UNITED STATES PATENT AND TRADEMARK OFFICE

APPLICATION NO.	FILING DATE	FIRST NAMED INVENTOR	ATTORNEY DOCKET NO.	CONFIRMATION NO.
09/870,418	05/30/2001	Michael K. Blackwell	C01104/70001	8017

Office Action Summary	Application No. 09/870,418	Applicant(s) BLACKWELL ET AL.	
	Examiner Sean P. Shechtman	Art Unit 2125

DETAILED ACTION

FIG. 1

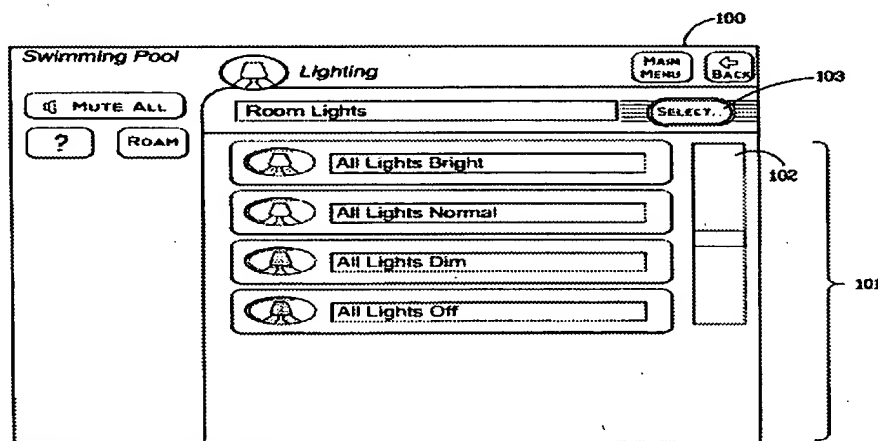
Referring to claims 68 and 84, Pyle teaches a system for preparing and playing back a light sequence, comprising an authoring interface displaying information representative of a plurality of lighting effects (bright and dim); a sequence authoring module to permit a user to select a lighting effect (bright or dim or intensity), a lighting unit to execute the lighting effect (room lights), a start time for the lighting effect, and a stop time for the lighting effect (Col. 5, lines 14-45); and a playback device, coupled to the lighting unit, to playback the light sequence (Col. 9, lines 34-64, especially lines 61-64).

Examiner respectfully notes that the instant specification teaches the term “light sequence” does not require sequential displays. In fact, the term “light sequence” only requires a controlled display with one light. The examiner respectfully submits that the lighting sequence is not required to be functionally related to or used with the authoring interface or sequence authoring interface.

Referring to claim 69, Pyle teaches the system of claim 68, further comprising a lighting set-up module to receive information representative of an arrangement of a plurality of lighting units, and a set-up interface to visually display the arrangement of the plurality of lighting units (See figure above).

Referring to claim 31, Pyle teaches the computer readable medium of claim 30, wherein the lighting program is encoded in a data format having an entry in the lighting program corresponding to every one of the plurality of states for the plurality of lights (See above figure).
